Veranda Estates

PRELIMINARY SUBDIVISION PLAT APPLICATION
WITH CONSTRUCTION PLANS

(P20-221)

Laura H. Dodd, Planner II

Request to exceed cul-de-sac length

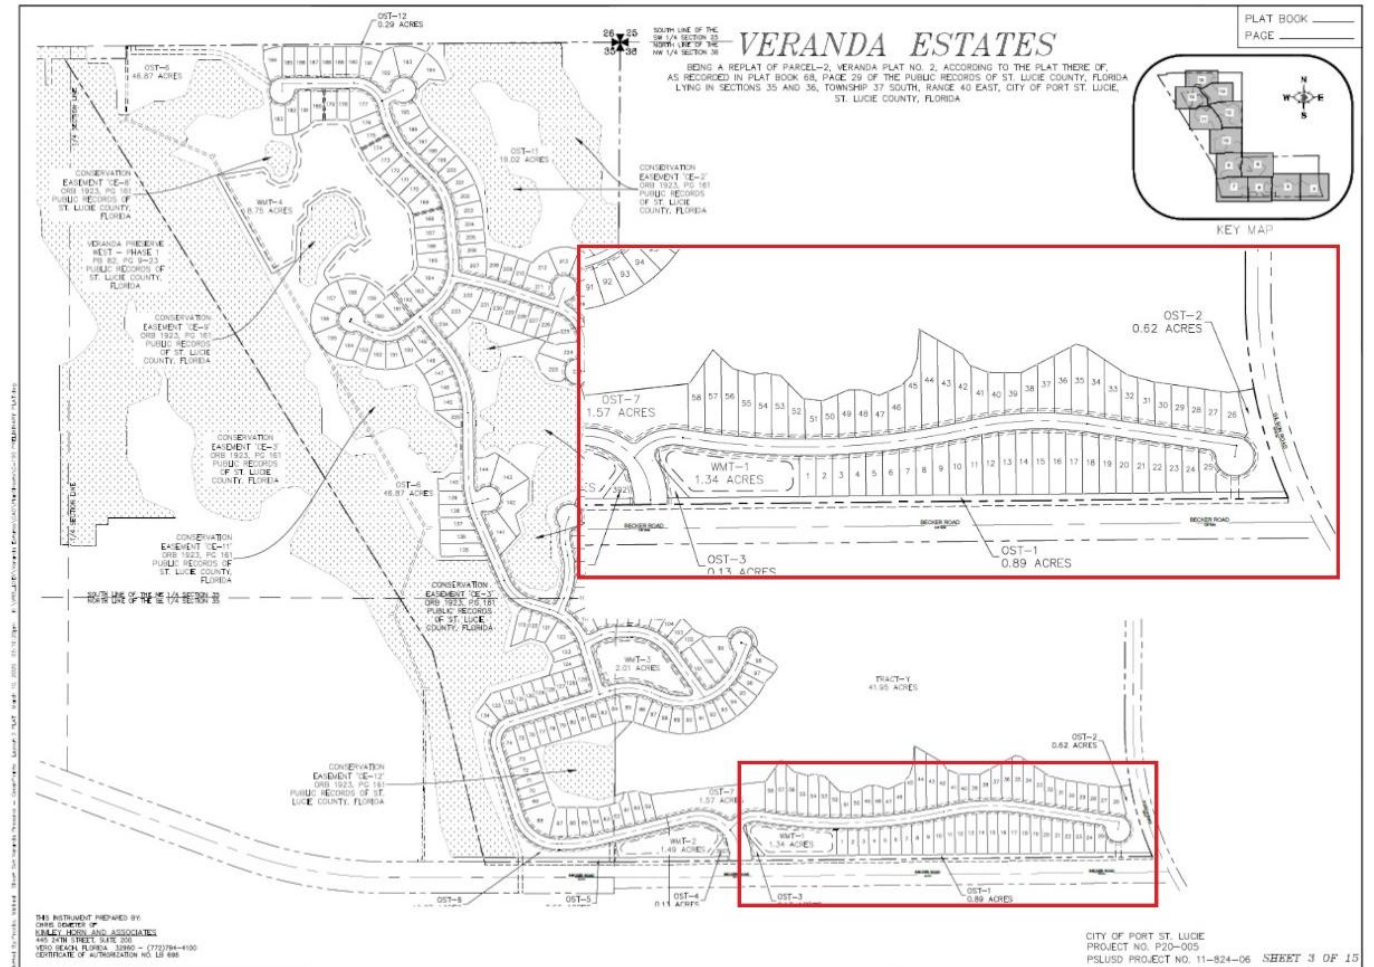
Permanent dead-end streets shall not exceed one thousand (1,000) feet in length without special permission of the Planning and Zoning Board; except where, due to unusual circumstances, a greater length may be deemed necessary.

The proposed length is approximately 1,850 feet.

The Planning and Zoning Board approved the cul-de-sac length at their May 5, 2020 meeting.
